Addendum 126 – Regulation No. 127

Revision 4 - Amendment 1

Supplement 1 to the 04 series of amendments to the Regulation – Date of entry into force: 5 January 2024.

Uniform provisions concerning the approval of motor vehicles with regard to their pedestrian safety performance

Figure 12
Windscreen test area

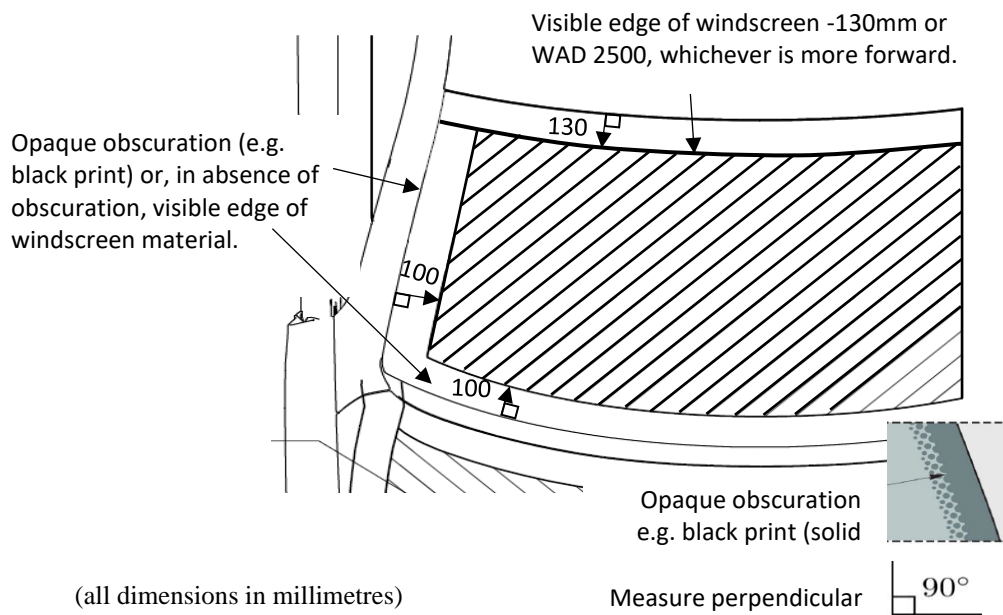
Paragraph 2.44., amend to read and insert Figures 12 and 13:

- "2.44. "Windscreen test area" is an area on the outer surface of the windscreen. It is bound (see figure 12):
- (a) In the front, by a line 100 mm rearward to the opaque obscuration of the windscreen. In case of absence of the opaque obscuration, the line is measured from the front visible edge of the windscreen material.
 - (b) In the rear, by a WAD 2,500 or a line 130 mm forward to the rear visible edge of the windscreen material, whichever is more forward at a given lateral position.
 - (c) At each side, by a line 100 mm inside the opaque obscuration of the windscreen. In case of absence of the opaque obscuration, the line is measured from the side visible edge of the windscreen material.

For (a) and (c): the distances of 100 mm are to be measured with a flexible tape held tautly along the outer surface of the vehicle at an angle of 90° to the tangent line to the opaque obscuration limit or in case of absence of the opaque obscuration, from the visible edge respectively.

For (b): the distances of 130 mm is to be measured with a flexible tape held tautly along the outer surface of the vehicle at an angle of 90 ° to the tangent line to the rear visible edge of the windscreen.

Figure 13
Upper corner definition with "shortest distance"

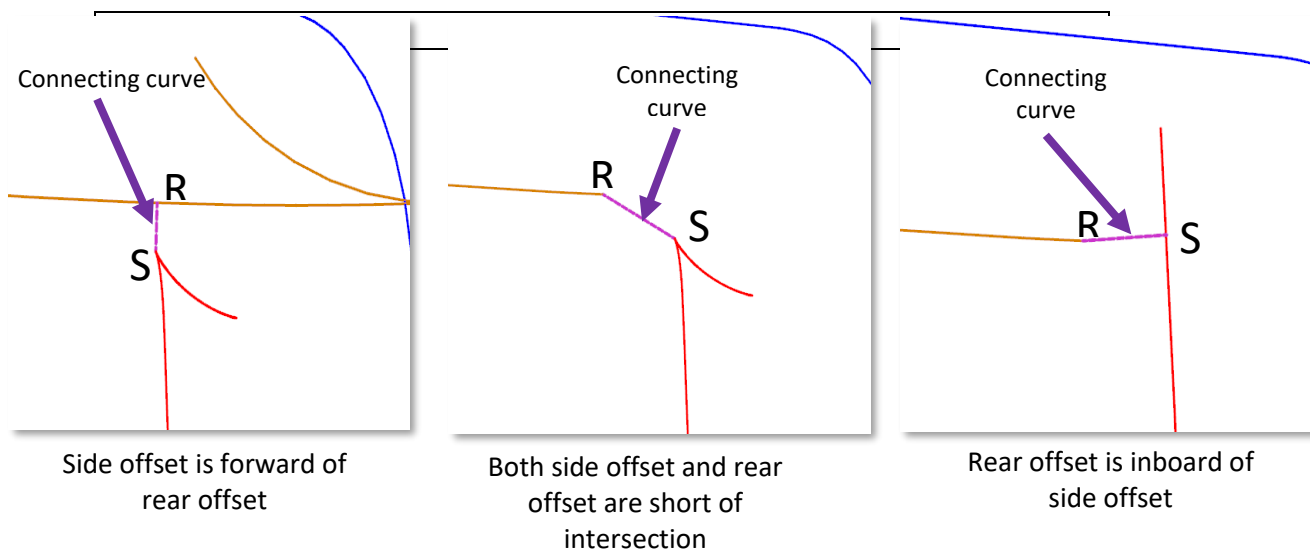
Depending on the geometry, in case there is no intersection between (b) and (c), resulting in an open test area, then the marking shall be modified using the shortest distance to close the open test area (see figure 13).

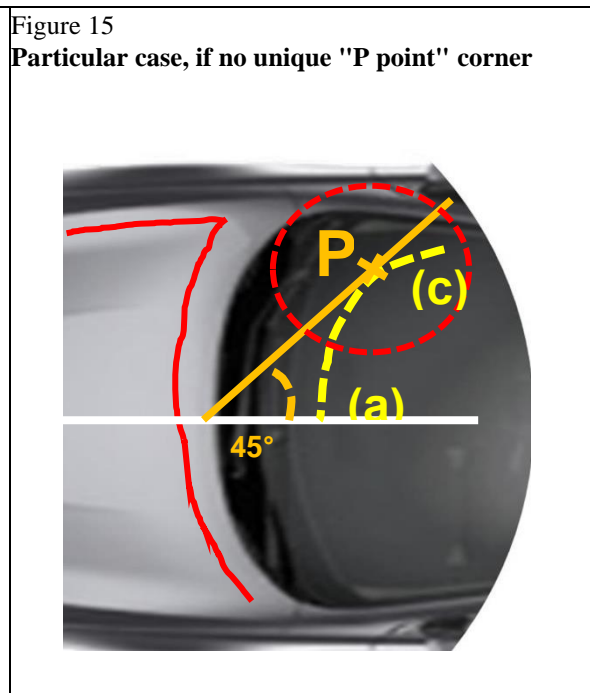
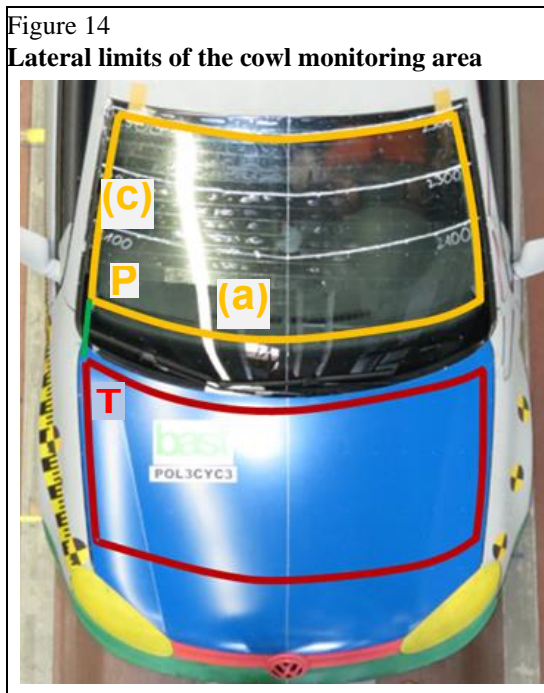
Paragraph 2.45., insert Figures 14 and 15 and amend to read:

At each side, the cowl monitoring area is bound by the TP line (see figure 14), where:

- (a) the "T point" is the rear corner of the bonnet top test area; and
- (b) the "P corner point" is the lower corner of the windscreen test area; using a flexible tape held tautly from point T to P.

If there is no unique "P point" where the lines defined in 2.44 (a) and (c) intersect, then the "P point" is defined by the first contact of a vertical plane intersecting the vertical longitudinal vehicle center-plane at an angle of 45° with the (a)-(c) transition of the windscreen test area boundary, as shown in Figure 15.

Figure 16
Jerk criterion graph and formula

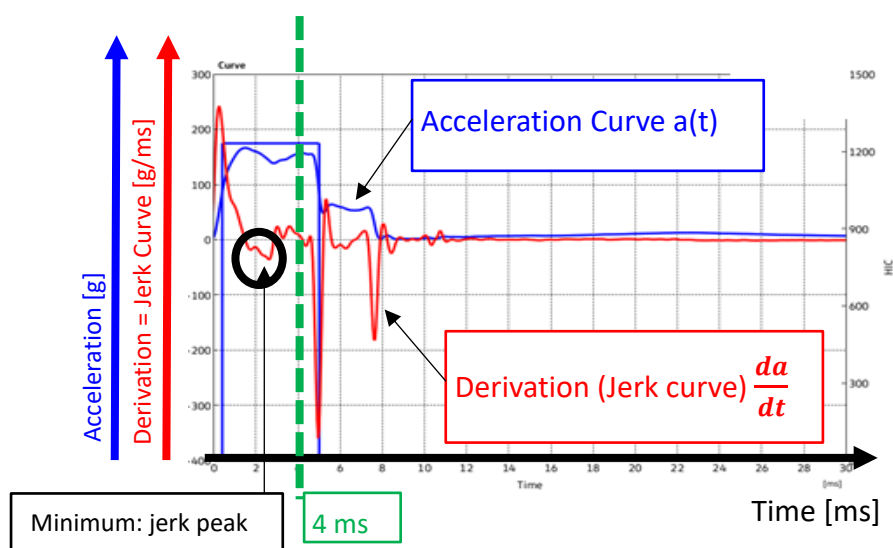
Paragraph 2.48., insert Figure 16 and amend to read:

"2.48. "Atypical windscreen fracture behaviour" is where the headform to windscreen impact results in at least one of the following cases:

- (a) The absolute value of the minimum value of the derivation of the headform acceleration versus time is less than 180 g/ms within the first 4 ms after the initial contact of the headform to the windscreen, as shown in Figure 16; or

$$\left| \min \left(\frac{da}{dt} \right) \right| < 180 \text{g/ms, for } 0 < t < 4 \text{ms}$$
